TYPE 1-31, GUARDRAIL WITH OMITTED POST

STANDARD NO. B-1 (2022)

SHT. 4 OF 5

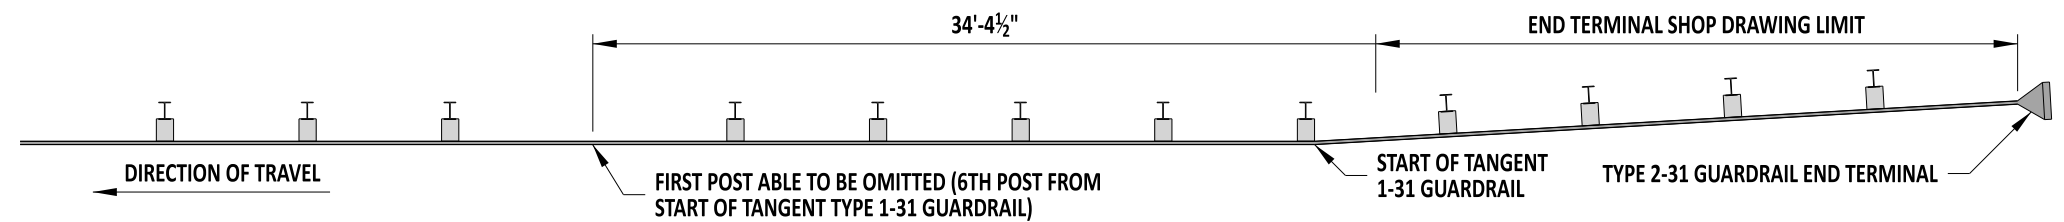
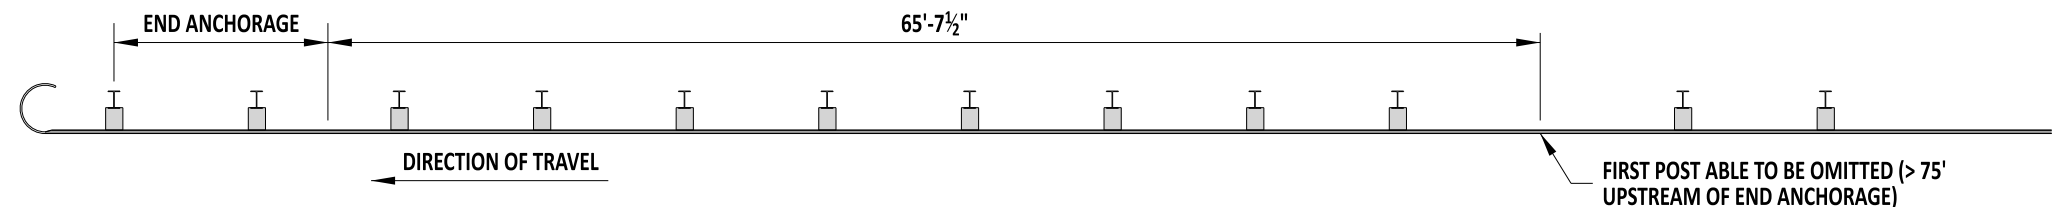
**OMITTED POST WITH A TYPE 1-31 GUARDRAIL END TERMINAL****OMITTED POST WITH A TYPE 2-31 GUARDRAIL END TERMINAL** **ISN'T OUR CURRENT 2-31 ALSO ENERGY ABSORBING?****OMITTED POST WITH AN END ANCHORAGE****NOTES:**
